December 9, 2011  
Subject: **Portland/Long Island**  
Federal Project No: STP-1745(510)S  
State PIN: 017455.10  
**Amendment No. 1**

STATE OF MAINE  
DEPARTMENT OF TRANSPORTATION  
CASCO BAY TIMBER PIER REHABILITATION  
WIN NO. 17455.10

SKETCH - 1  
ADDENDUM NO. 1

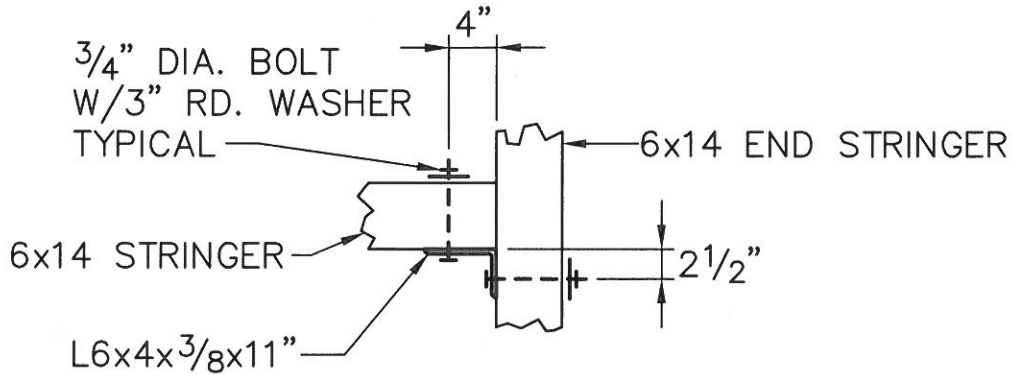
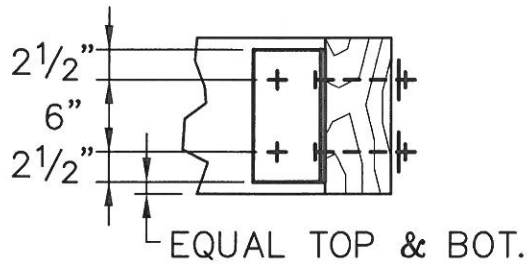
**Question:** Reference Plan Sheet S5 (12 of 24), "FRAMING PLAN" top timber between (16) and (15). How does the end timber attach to the new Joists?

**Response:** Please see the attached sketch labeled "SKETCH - 1, ADDENDUM NO. 1".

STRINGER END CONNECTION DETAIL

NOTE: USE SAME CONNECTION AT ALL SIMILAR CONDITIONS
